# PARTS & SERVICE NEWS

REF NO.	AT98108A
DATE	May 6, 1999

**SUBJECT:** T/M IMPROVED DURABILITY PARTS ON HD785-3

**PURPOSE:** To introduce improved-durability parts for the transmission of HD785-3 dump trucks

3. Introduction of the improved 3rd clutch with enhanced durability

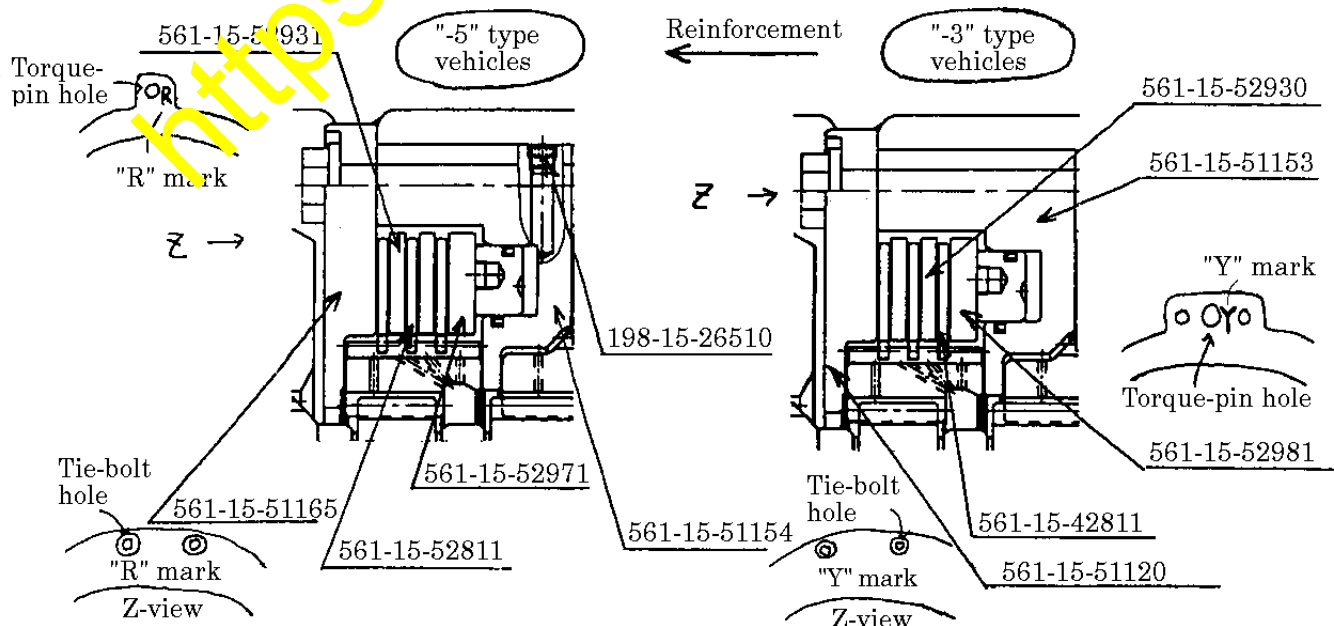
- (1) A new disc material (molded heat resistant resin) with higher heat-resistance capacity has been employed for the clutch discs. (The wear life is about 1.3 times that of the current part.)  
 Moreover, when determining to reuse or not at times of overhauling, although conventional rubber material discs were always replaced totally regardless of the extent of wear because of occurrence of the thermo-hardening deterioration, this new material is free from thermo-hardening. As to whether to reuse these new discs or not, can be determined purely by the extent of wear of these discs. They should be replaced only when the parts are found worn beyond the prescribed wear limit.
- (2) To prevent occurrence of hydraulic chattering with the 3rd clutch, a bleed off means (constant leakage hole) has been supplemented to the 3rd clutch circuit.

Comparing vehicle models			HD785-5			HD785-3 (the third improvement)		
Contents of the modification	Part names	Difference between "-5" and "-3" type vehicles	Part numbers	Q'ty/vehicle	Identification marking	Part numbers	Q'ty/vehicle	Identification marking
Fellow parts for the high-load discs	Disc	Part number	561-15-52811	3	Waffle grooving	561-15-42811	3	Radial spiral grooving
		Material	G525			Payflex		
	Plate (Piston)	Part number	561-15-52971	1		561-15-52981	1	A 'Y' mark is being provided beside the torque-pin hole
		Surface coarseness	1.6S			5S		
		Thickness	10.2			10.2		
	Plate (End)	Part number	561-15-51165	1	An 'R' mark is being provided below the tie-bolt hole.	561-15-51120	1	A 'Y' mark is being provided below the tie-bolt hole.
		Surface coarseness	1.6S			5S		
	Plate	Part number	561-15-52930	2	An 'R' mark is being provided beside the torque-pin hole.	561-15-52930	2	
Surface coarseness		1.6S			5S

Necessary parts for prevention of hydraulic chattering of the 3rd clutch	Housing	Part number	561-15-51154	1		561-15-51153	1	
		PT threading as the bleed-off means	Provided.			Not provided.		
	Plug	Part number	198-15-26510	1		---	---	
		Plug as the bleed off means	Provided.			Not provided.

Notes) Always replace all the parts listed above at the same time.

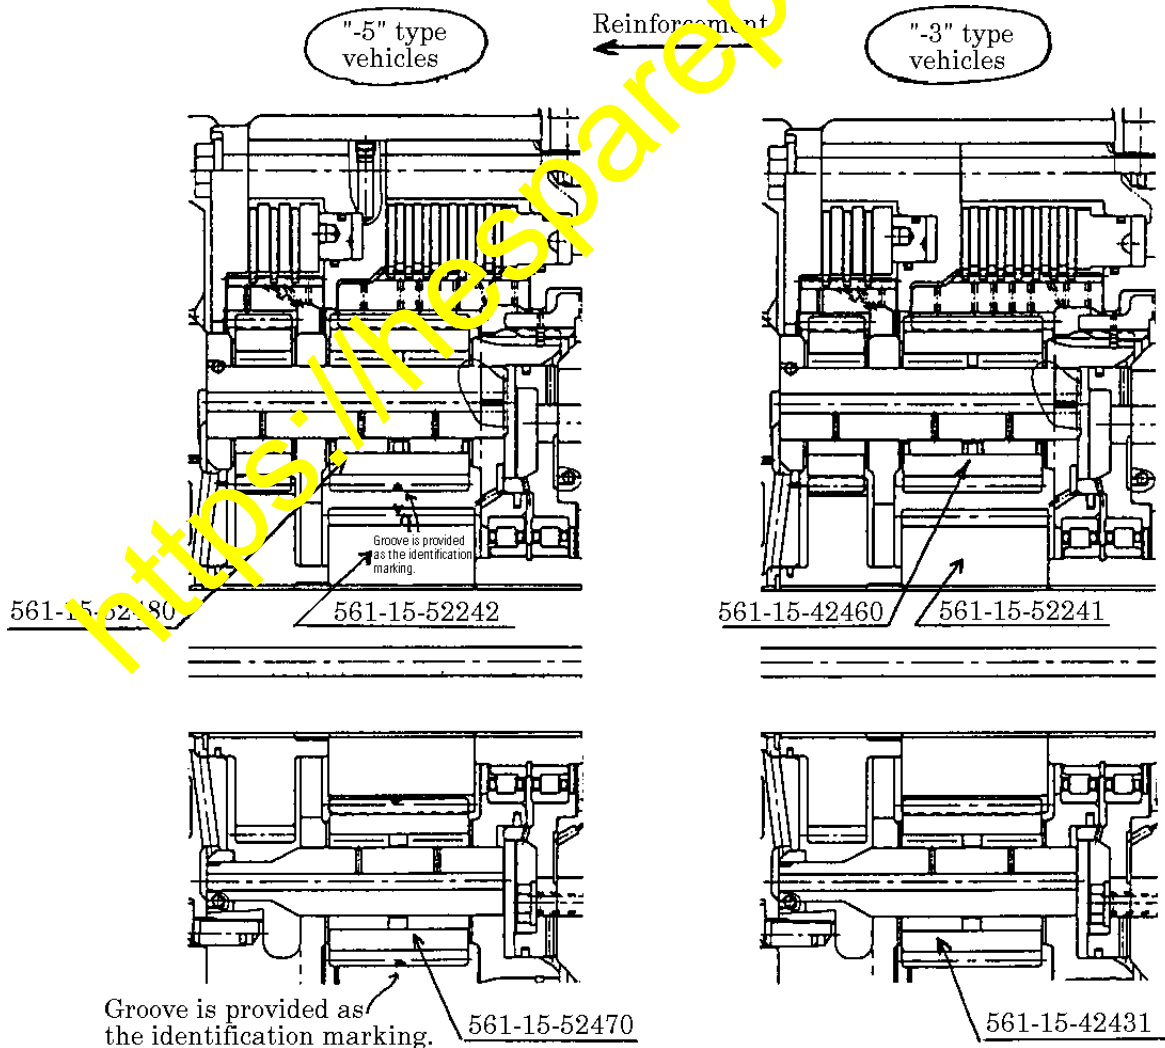
4. Introduction of the improved R-train planetary gears with enhanced durability  
 With the HD785-5, bending life of the R-train planetary gears have been improved to about 1.3 times as long as those of the current parts by supplementation of hard shot peening. Indicted below is a list of necessary parts when installing this improved part with enhanced durability originally prepared for the HD785-5 to the HD785-3.

Comparing vehicle models			HD785-5			HD785-3 (the third improvement)		
Contents of the modification	Part names	Difference between "-5" and "-3" type vehicles	Part numbers	Q'ty/ vehicle	Identification marking	Part numbers	Q'ty/ vehicle	Identification marking
R-train gears supplemented with the hard shot peening treatment	Gear (Sun)	Part number	561-15-52242	1	A groove of 0.1 – 0.3 is being provided in the center of the addendum.	561-15-52241	1	KHP
		Heat treatment	KHP+HSP					
	Gear (No. 1 Pinion)	Part number	561-15-52470	4	A groove of 0.1 – 0.3 is being provided in the center of the addendum.	561-15-42431	4	KHP
		Heat treatment	KHP+HSP					
	Gear (No. 2 Pinion)	Part number	561-15-52480	4	A groove of 0.1 – 0.3 is being provided in the center of the addendum.	561-15-42460	4	KHP
		Heat treatment	KHP+HSP ※

Notes) Always replace all the parts listed above at the same time.
